**From:** Mess, Camie  
**Sent:** Tuesday, August 15, 2017 2:58 PM  
**To:** clifffox2@gmail.com  
**Subject:** BAR Action - 419 East Main Street - Aug. 14th, 2017

**Certificate of Appropriateness Application**

BAR 17-08-05  
419 East Main Street  
Tax Parcel 530062000  
Holly Ridge, LLC, Owner/ Clifford H. Fox, Applicant  
Window Replacement

Window Replacement

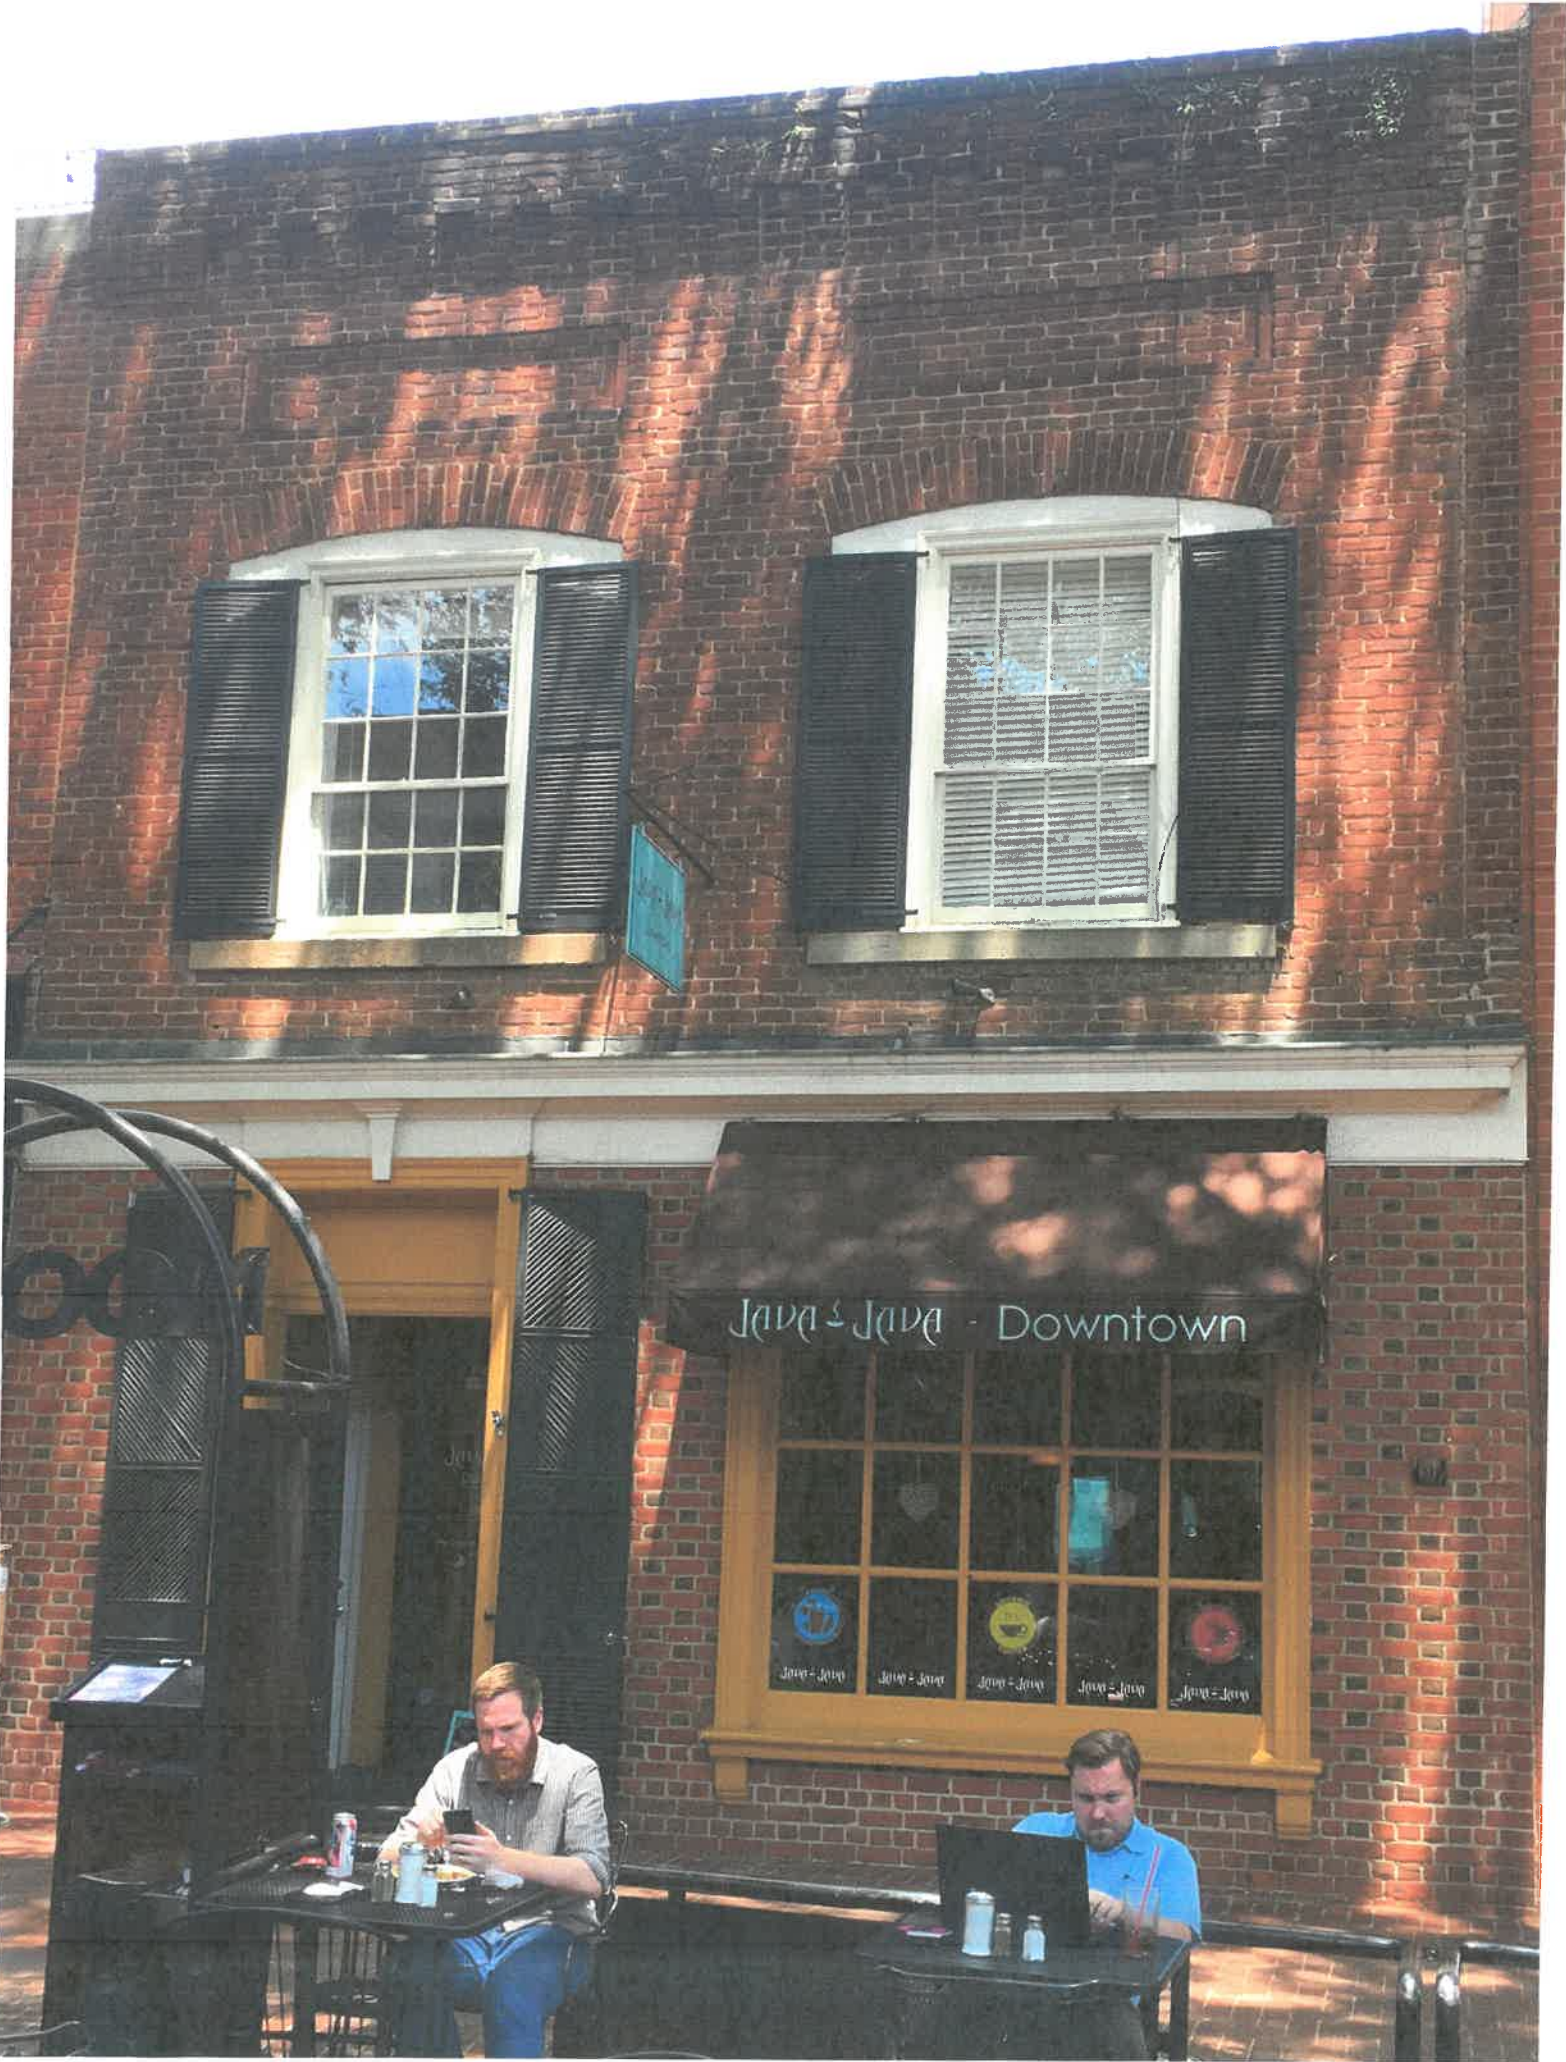
The interior photo from the apartment at 419 East Main shows one of the damaged balances.

Balance  
Ribbon  
Pulled away  
& inoperable.

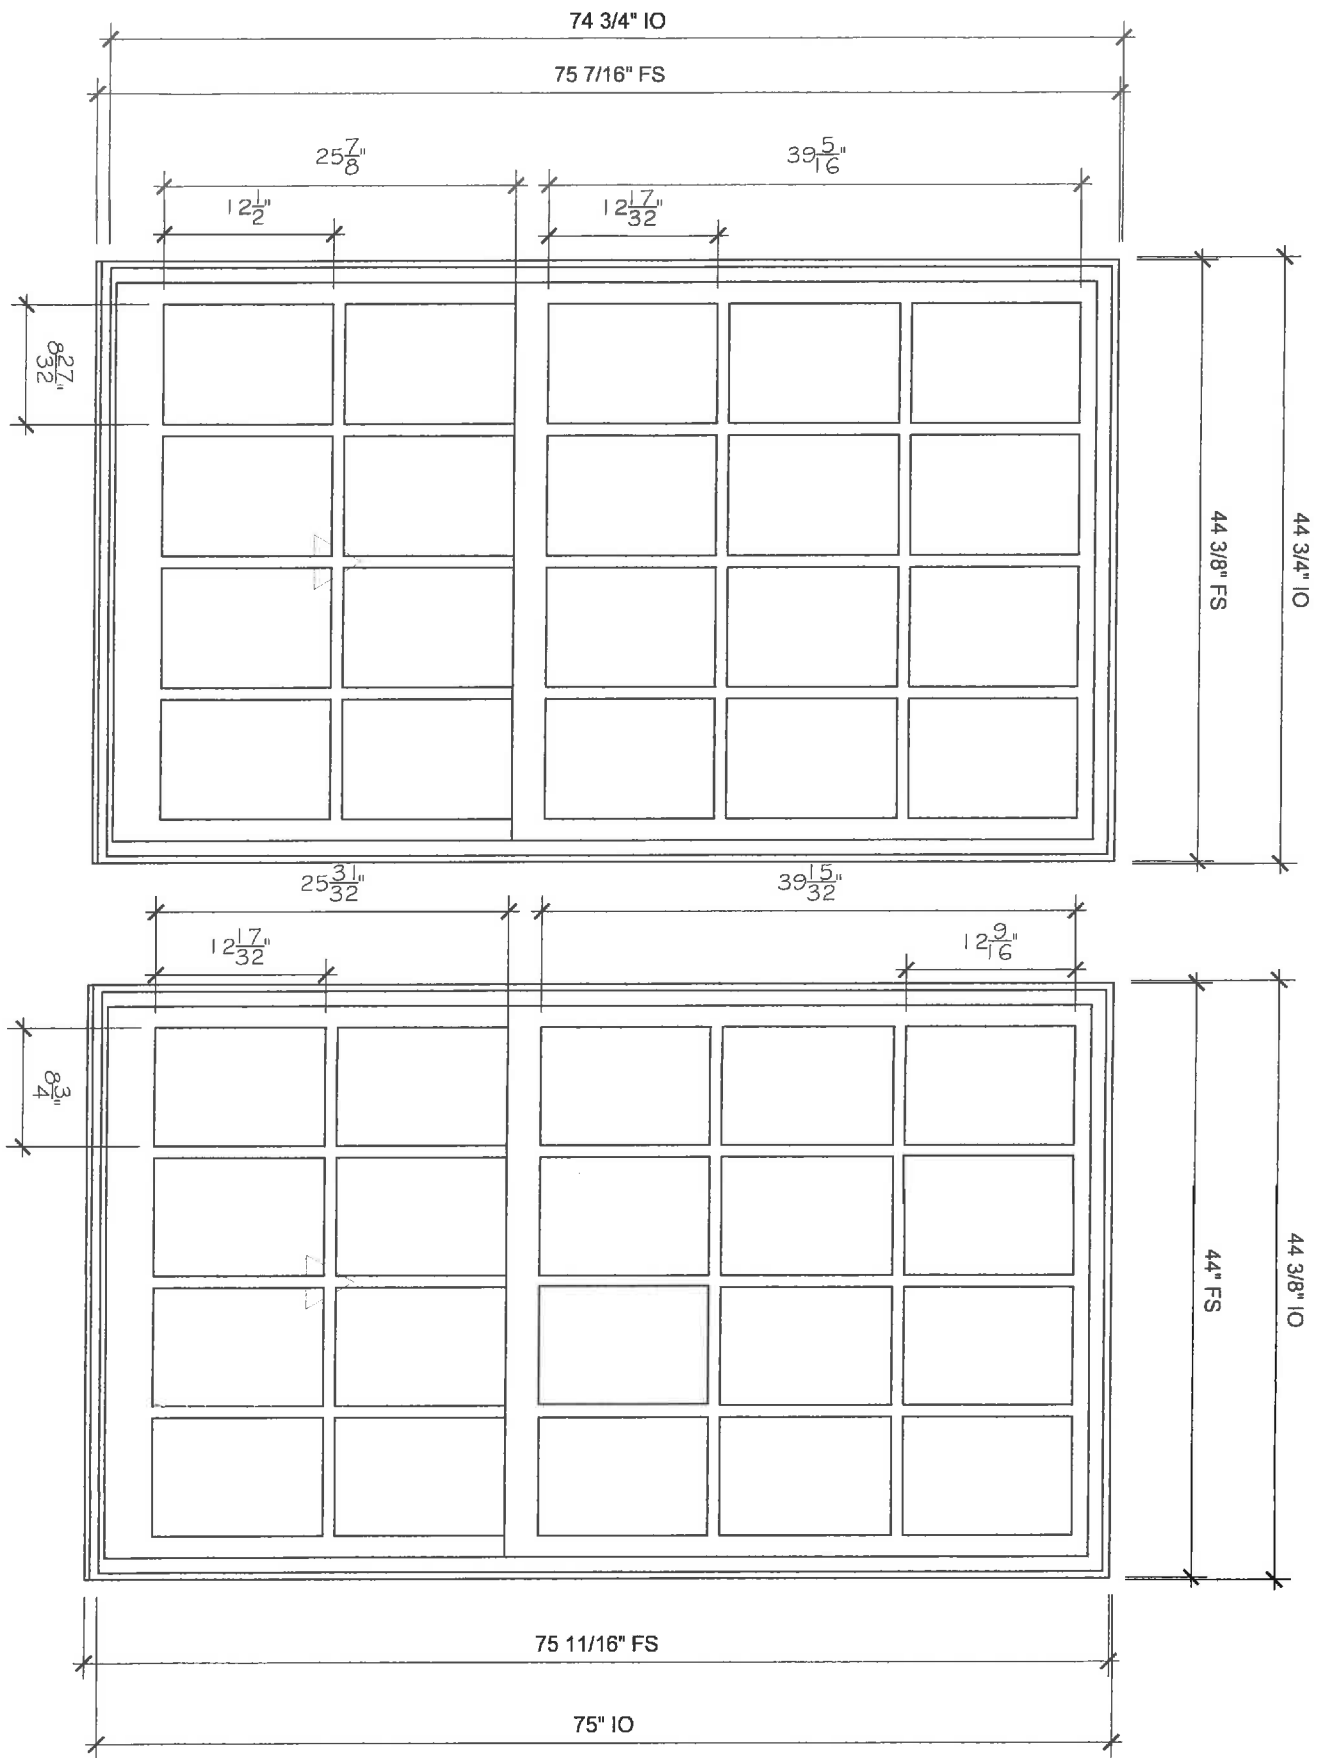
The sash, muntin, and other window components are as close to the existing windows as could be designed within Marvin's manufacturing specifications. I provided three (3) color panels with the application: Coconut, Sierra, and White; hopefully they are available for your review. We would use the color closest to the existing color on the windows. The surrounding trim and stucco will be repainted to match the proposed Clad replacement windows. **There is a clip in trim component to hide a seam on the exterior of the window, this is shown in the upper left hand corner of the photograph in the packet showing the exterior view of the window and is attached here as 08092017 Figure #1.** The sash and pane configuration will be what is shown on the plan, attached here as 08092017 Figure #2.
